## MEMORANDUM

**SUBJECT:** SITE PLAN CONTROL APPLICATION SPC 19 142354  
New Single Detached Dwelling  
45 John Street  
Thornhill Heritage Conservation District

ELEVATION NORTH

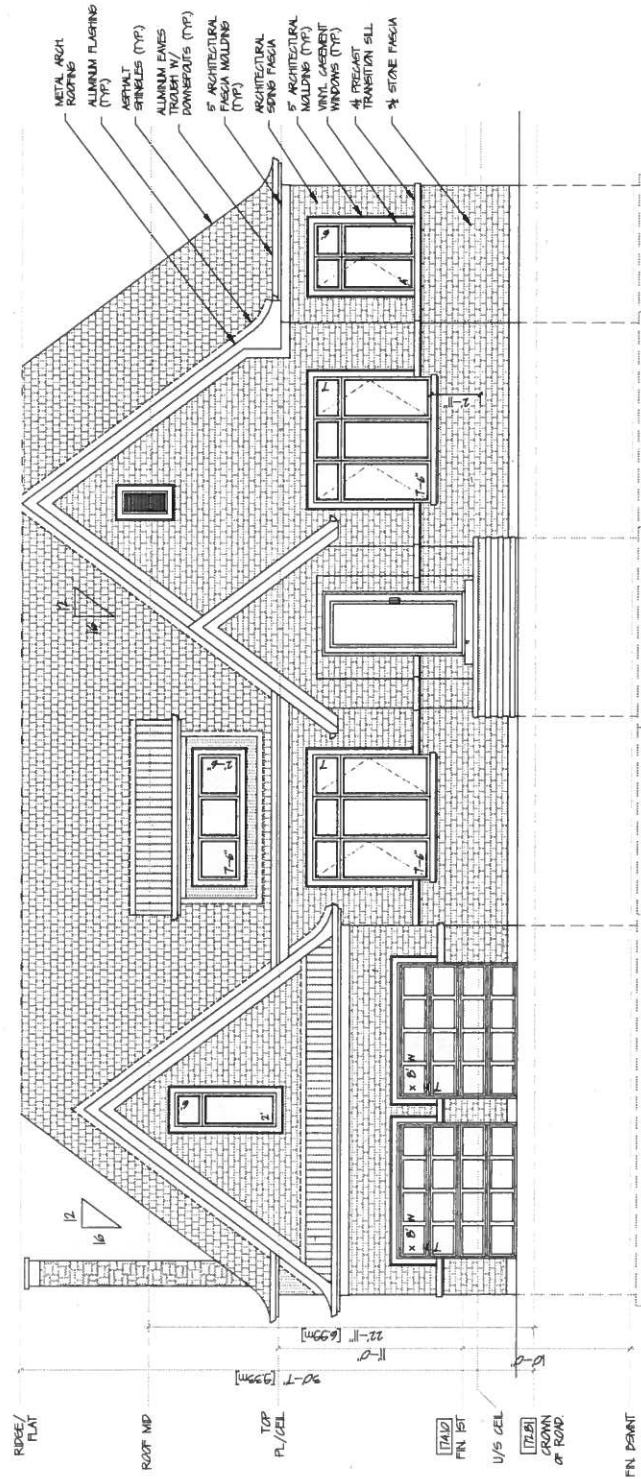
- Recommendations provided by Staff at the Pre-Consultation Meeting regarding the building design have not been addressed in the formal submission. Staff recommended that the garage recess from the building's main façade by a minimum of 1 metre to conform to the policies and guidelines of the Thornhill Heritage Conservation District Plan. Also, the cladding materials were somewhat different at the Pre-Con stage.

- Staff recommends that the garage be recessed a minimum of 1.0m and that consideration be given to its cladding treatment to a material other than brick.

- Staff recommend that the applicant revise the proposed window glazing design to include pane divisions which reflect the 'Arts and Crafts' architectural style influences of the building. Also the issue of the architectural treatment of window surrounds needs to be further discussed. Door treatment to reflect the Arts and Craft movement needs to be illustrated.

- Wall cladding materials need to be clearly identified – it appears that all walls are now a red brick. Unclear if the stone skirting is still proposed as well as the removal of wood or wood-like siding which was previously used to offer some relief.

**ELEVATION  
SOUTH**

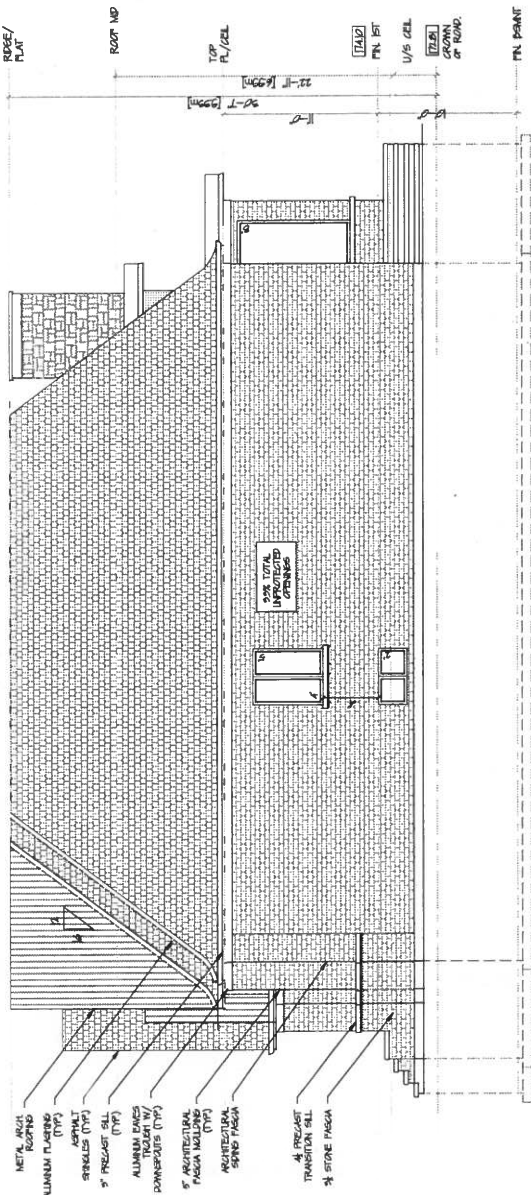
- It is possible that the large rear windows do not comply with the City of Markham Bird Friendly Guidelines. The addition of window pane divisions would be beneficial in the prevention of bird strikes.

PLAN ROOF

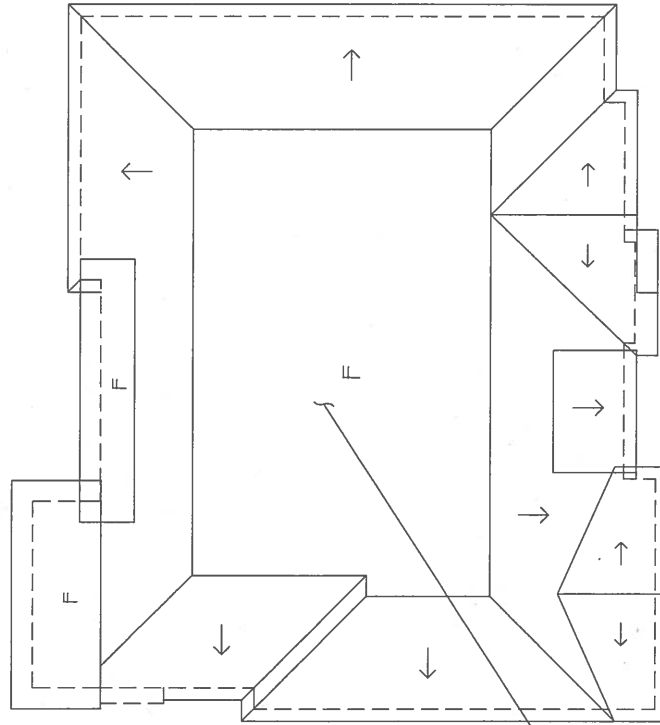
- Metal roofs are not supported in the District Plan.
- Utility and service connection location needs to be identified (not the front elevation)
- Staff recommend that the applicant address the changes as outlined above and that the application come back to Heritage Markham for review and comment.
